REGIONAL REVIEW NOTIFICATION

ARC REVIEW CODE: R1904021

Name of Proposal: 85 South Commerce (DRI 2915)

85 SOUTH COMMERCE CENTER DRI
City of Union City
Natural Resources Group Review Comments

DRAWING NO.:
C-1.0

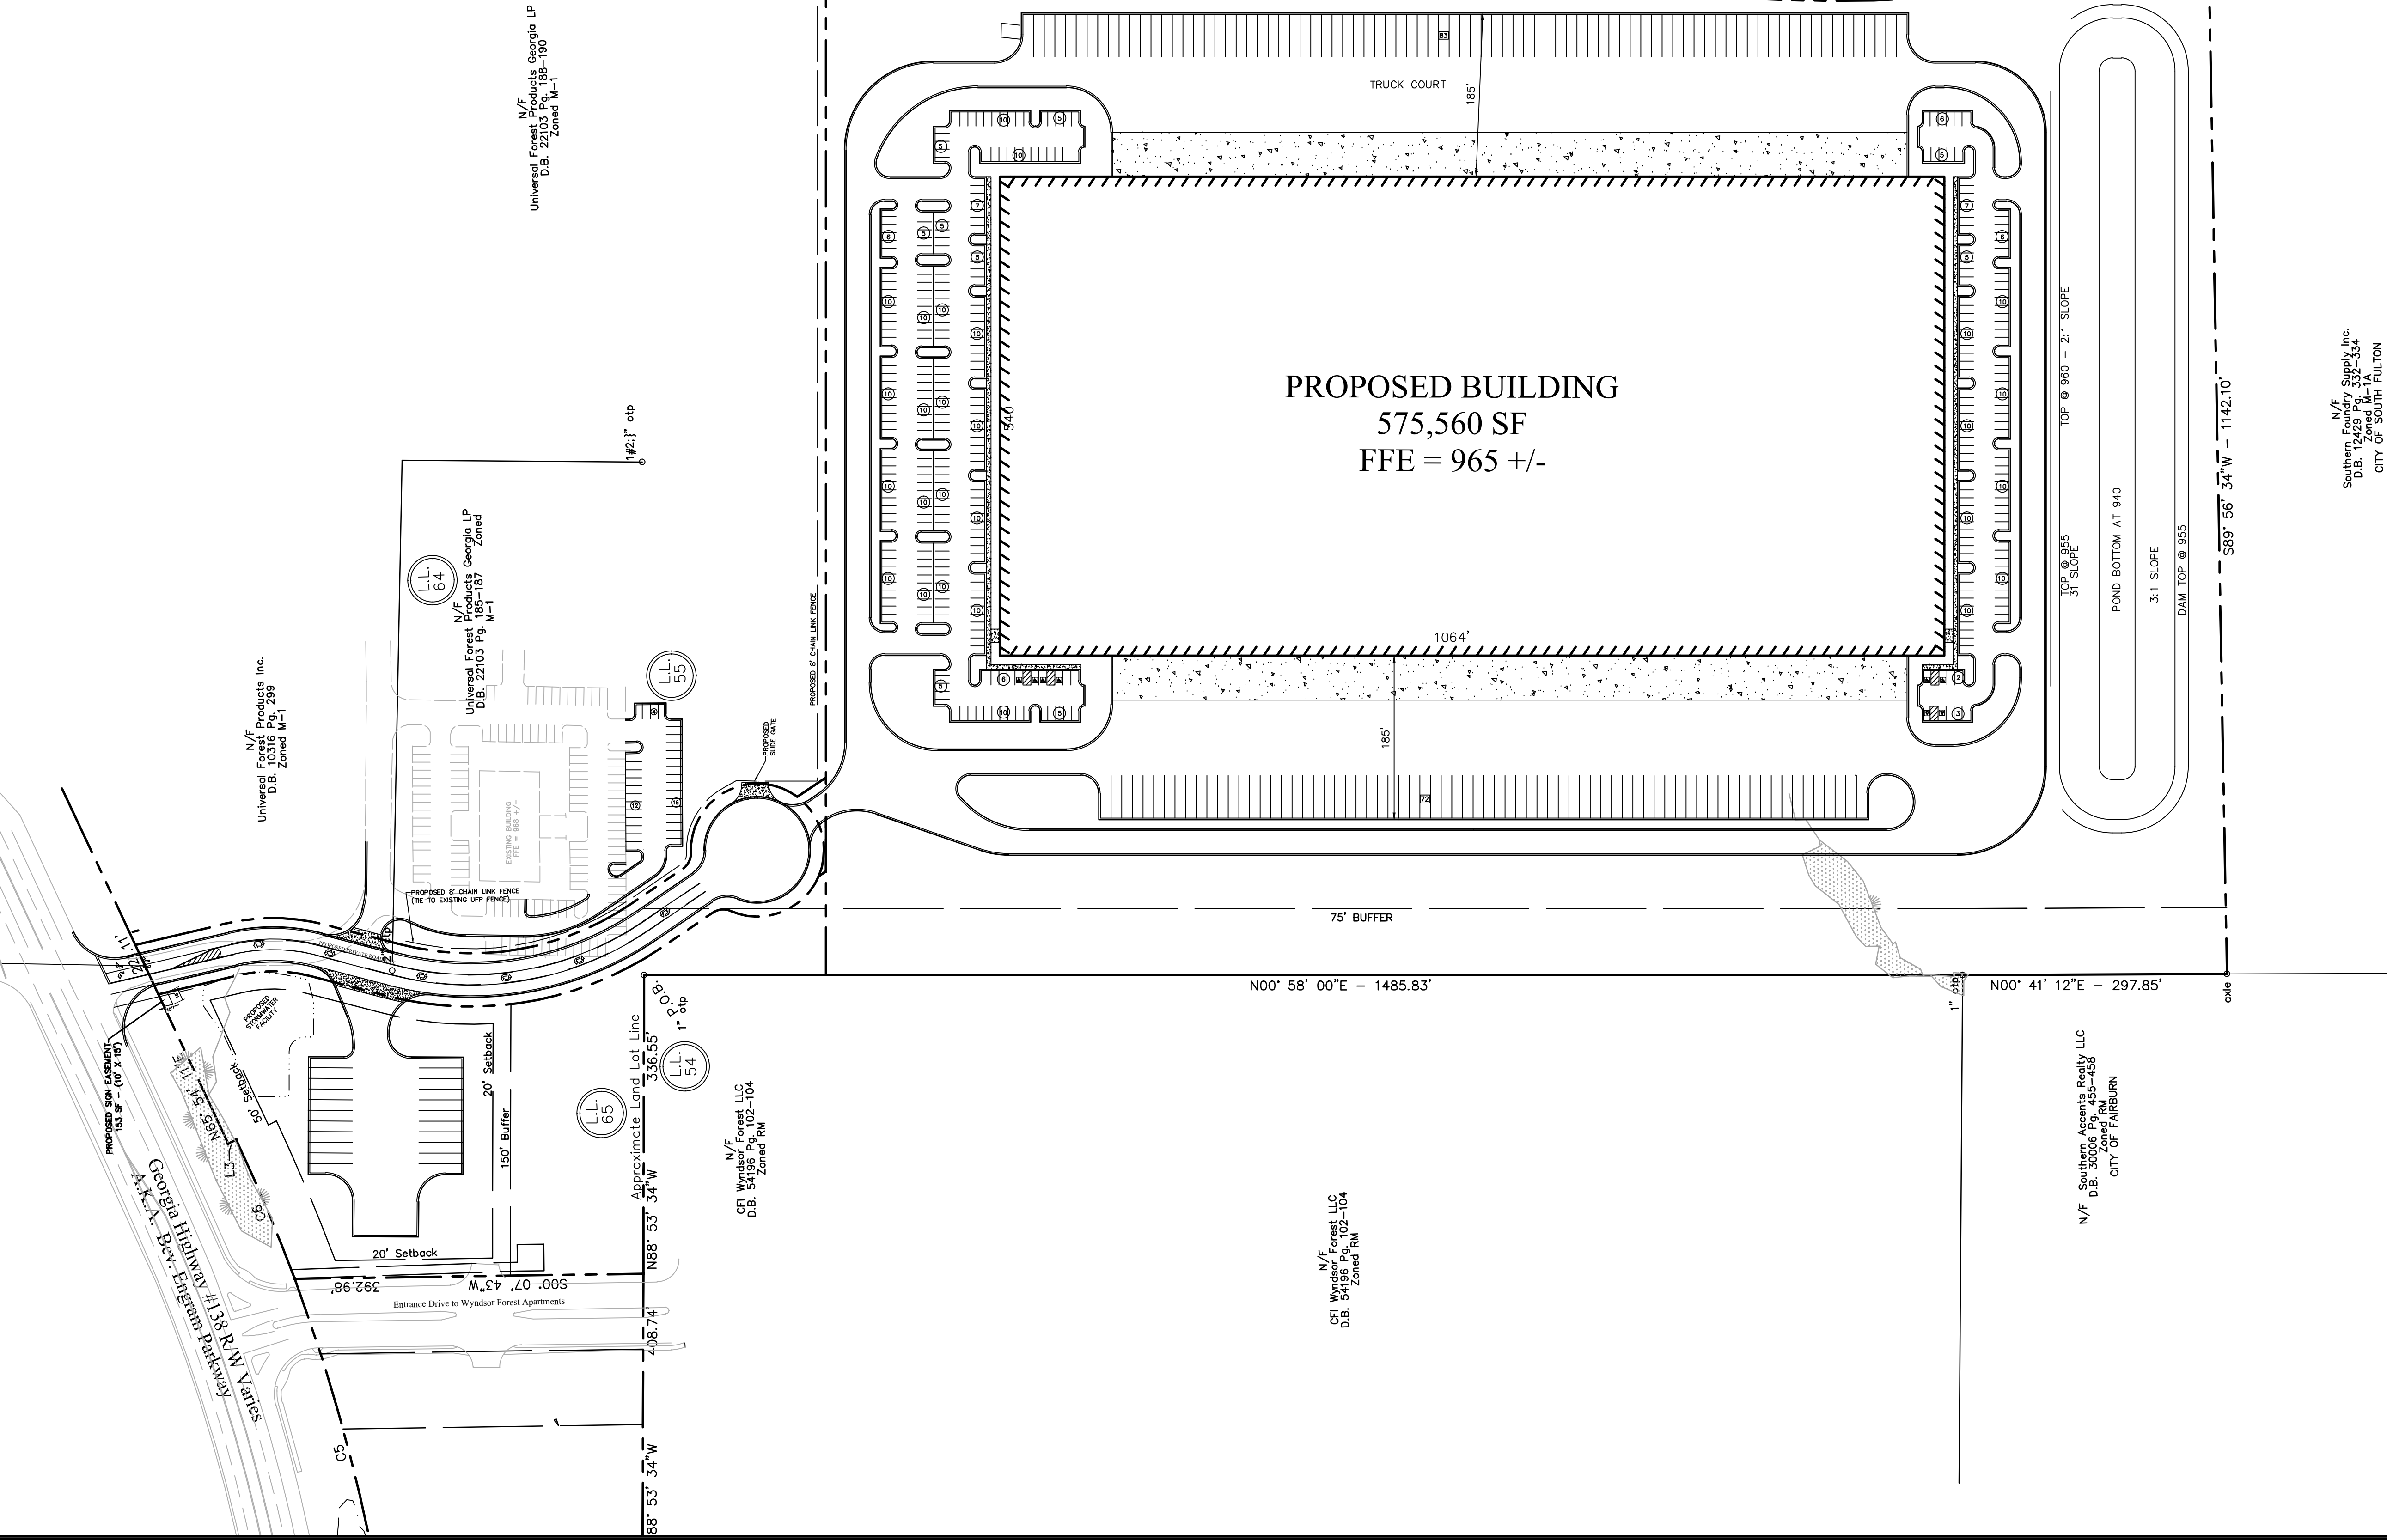
In addition, the development team should ensure that HWY 138 and Gresham Street is improved to accommodate the DRI project traffic, especially trucks, as shown on the submitted site plan. Finally, the applicant/development team, City of Union City, Fulton County DOT and GDOT will need to continue coordination regarding the planned improvements, shown on the site plan.

The site plan shows a proposed detention pond at the southern end of the property. The final design for stormwater controls on the property should adequately address the impacts of the proposed development on stormwater runoff and downstream water quality. Also, during construction, the project should conform to the relevant state and federal erosion and sedimentation control requirements. After construction, as with all development, water quality will be impacted due

As mentioned above, continued coordination will be required regarding planned improvements, shown on the site plan, to the intersection of HWY 138 at Gresham Street. As the site is also within one mile of a fixed route bus service, MARTA bus route 180, the planned access improvements to the site via the proposed private drive should include sidewalks and other pedestrian safety improvements. The development should not preclude providing interparcel access to the undeveloped parcel to the south.

The site plan identifies one (1) proposed driveway off Hwy 138.

The development offers one shared access point for vehicles and freight traffic.

OVERALL GRADING & DRAINAGE

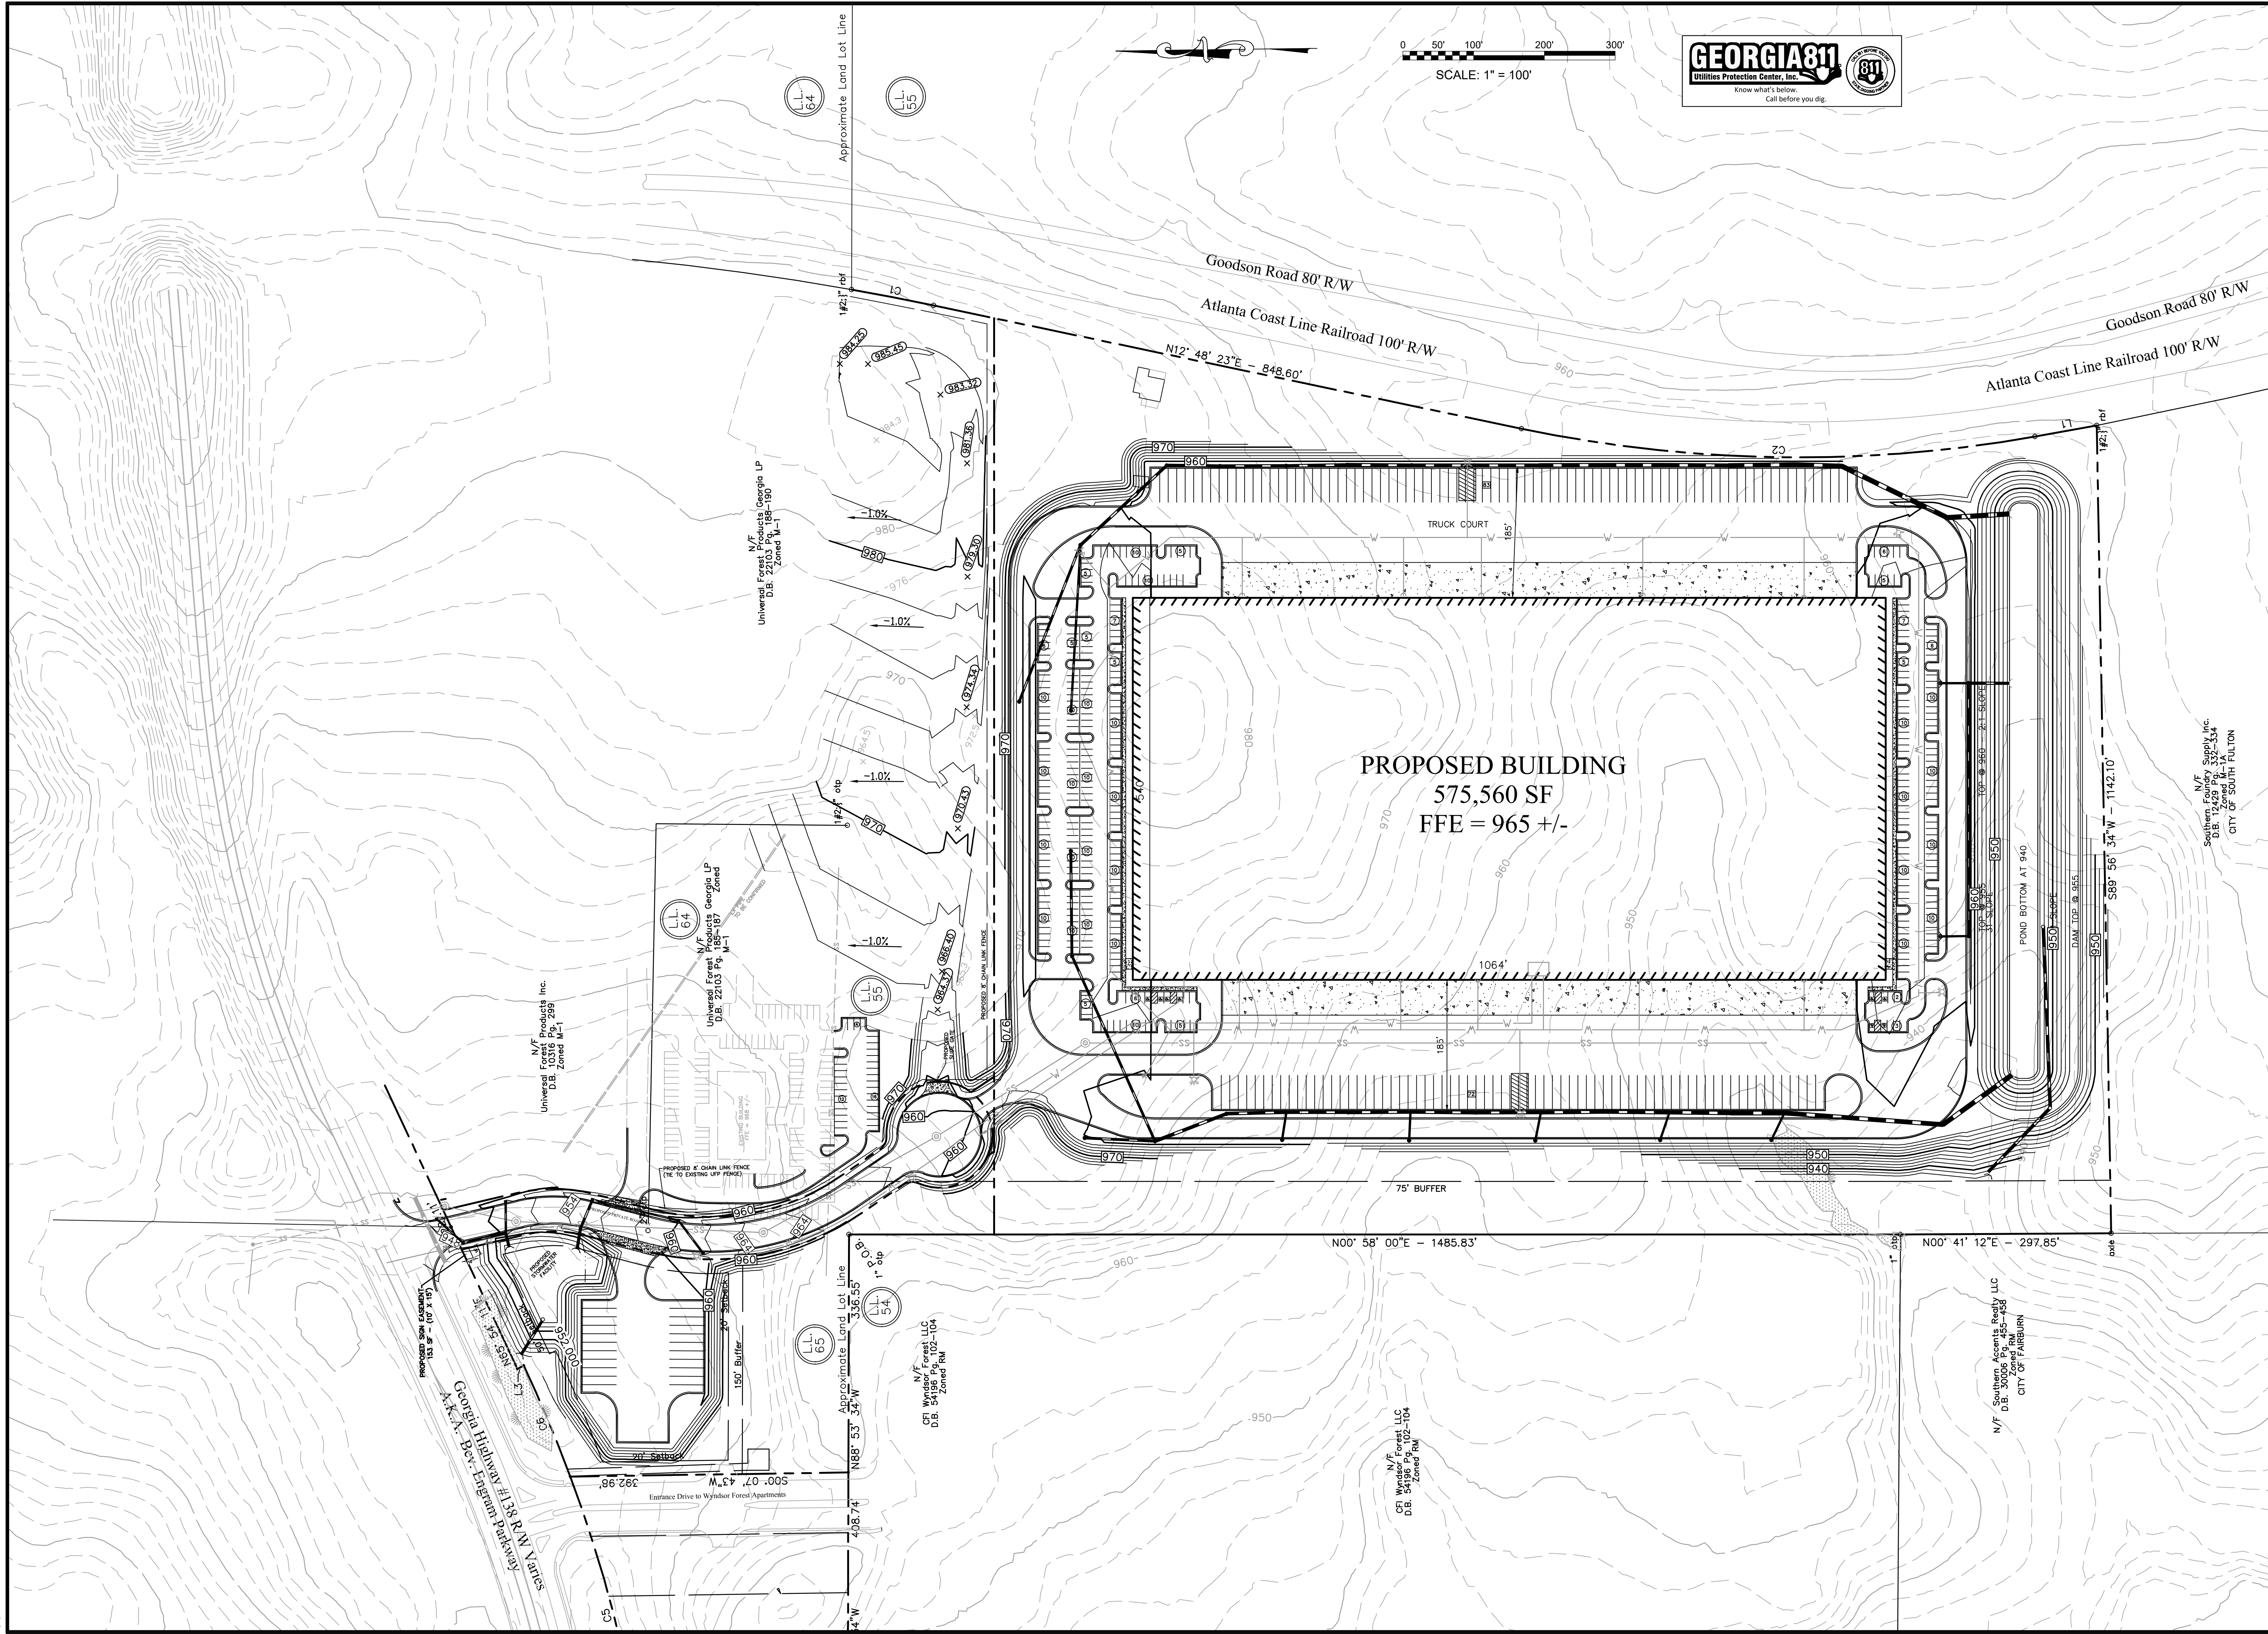
The proposed project is within the Whitewater Creek Water Supply Watershed, which is a small (less than 100 square mile) watershed that serves as a public water supply source for both Fayette County and the City of Fayetteville. The proposed project property is more than 7 miles upstream of both the County and City intakes. The USGS coverage for the project area shows no streams on or adjacent to the project property. The site plan shows an unidentified stream and possible wetland area in the southwest corner of the property. No buffers are shown, and both grading and paving are proposed over the indicated stream.

The site plan shows a proposed detention pond at the southern end of the property. The final design for stormwater controls on the property should adequately address the impacts of the proposed development on stormwater runoff and downstream water quality. Also, during construction, the project should conform to the relevant state and federal erosion and sedimentation control requirements. After construction, as with all development, water quality will be impacted due to polluted stormwater runoff. The amount of pollutants that will be produced after construction of the proposed development are dependent on the type and intensity of the use and the impervious coverage, which will affect the design of stormwater controls for the project.
